UNITED STATES PATENT AND TRADEMARK OFFICE

10/542,067

Office Action Summary	Application No. 10/542,067	Applicant(s) KUBOTA, KATSUHIRO	
	Examiner ANATOLY VORTMAN	Art Unit 2835

DETAILED ACTION

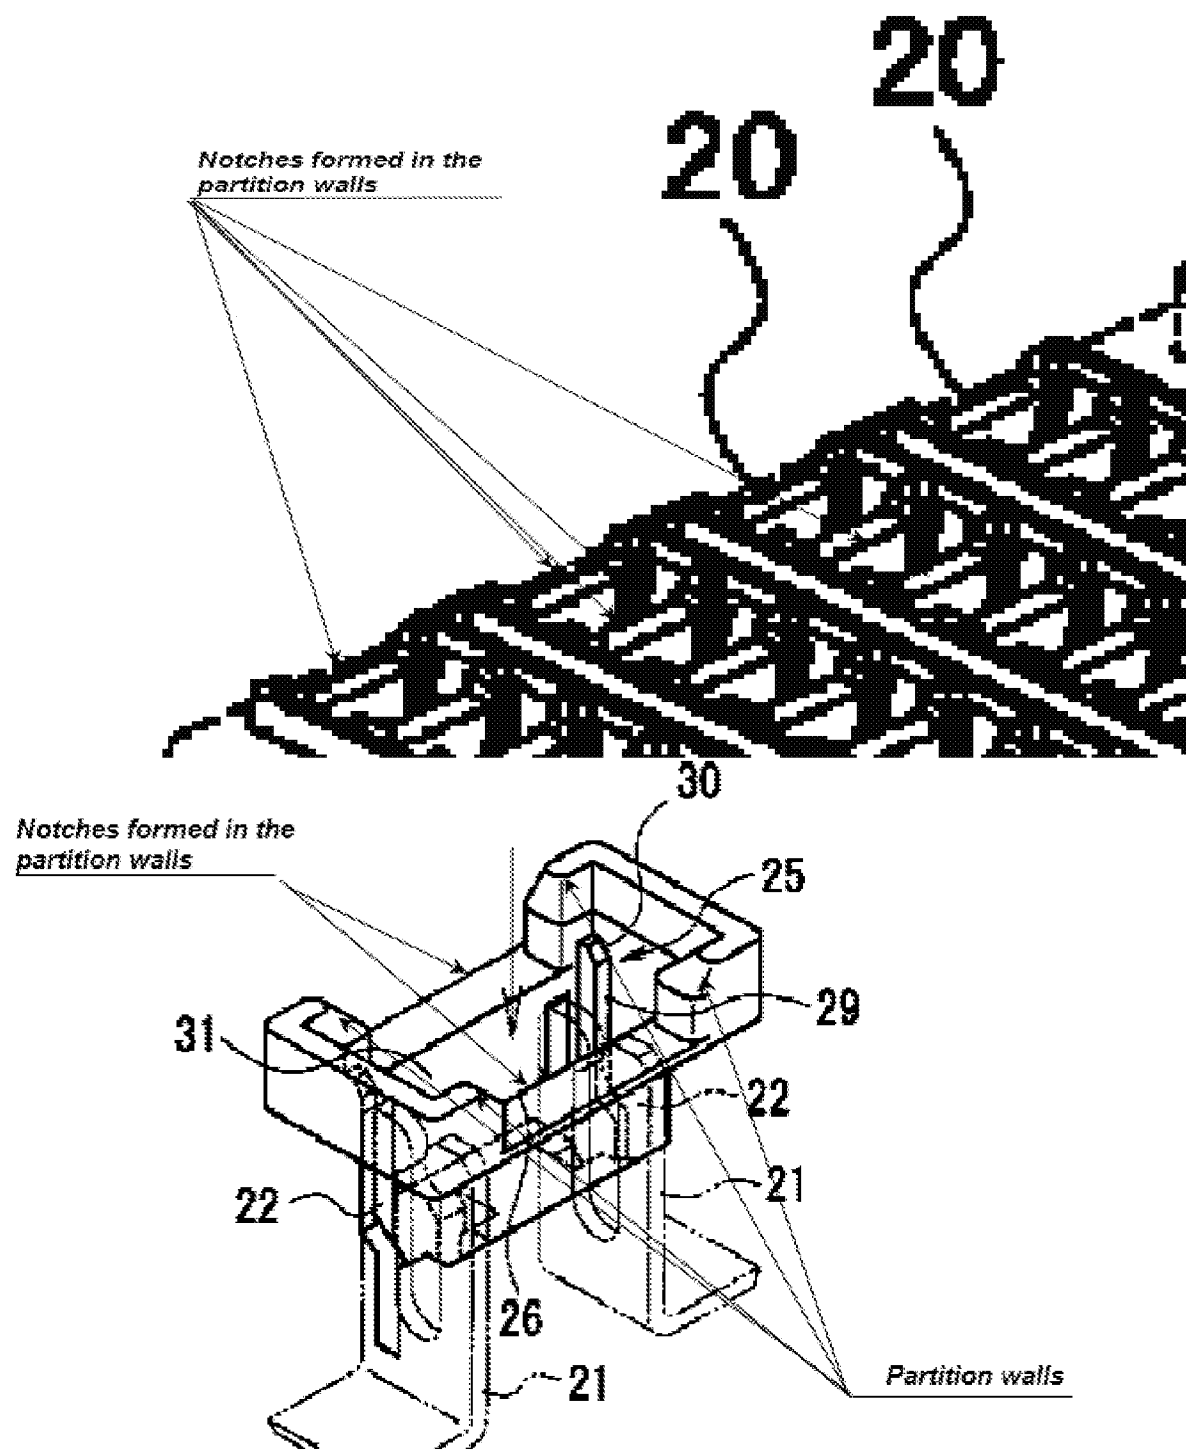
4. Claims 13-16, are rejected under 35 U.S.C. 102(b) as being **clearly** anticipated by JP/2002-124,175 to Kubota (of record).

Regarding claims 13 and 15, Katsuhiro disclosed (Fig. 1-11) a fuse cavity structure, comprising: a housing (34) provided with a plurality of fuse attachment portions (20) divided by partition walls, a large-sized fuse (50) and a small-sized fuse (10) shorter than the large-sized fuse being attachable to the fuse attachment portions, wherein each of the fuse attachment portions are adapted to accommodate the large-sized fuse or the whole small-sized fuse, such that both fuse sizes are accommodated interchangeably in each fuse attachment portion, and wherein a part of the partition wall which is opposed to a part of the small-sized fuse accommodated in the fuse attachment portion is cut as a through-hole to form a notch, the notch communicating adjacent fuse attachment portions to each other (see annotated fragments of Fig. 1 and 5 below).

Regarding claims 14 and 16, Katsuhiro disclosed (Fig. 1-11) an electric connection box comprising a fuse cavity structure (Fig. 5), the fuse cavity structure including: a housing (34) provided with a plurality of fuse attachment portions (20) divided by partition walls, a large-sized fuse (50) and a small-sized fuse (10) shorter than the large-sized fuse being attachable to the fuse attachment portions, wherein each of the fuse attachment portions are adapted to accommodate the large-sized fuse or the whole small-sized fuse, such that both fuse sizes are accommodated interchangeably in each fuse attachment portion, and wherein a part of the partition wall which is opposed to a part of the small-sized fuse accommodated in the fuse attachment portion is cut as a through-hole to form a notch, the notch communicating adjacent fuse attachment portions to each other (see annotated fragments of Fig. 1 and 5 below):
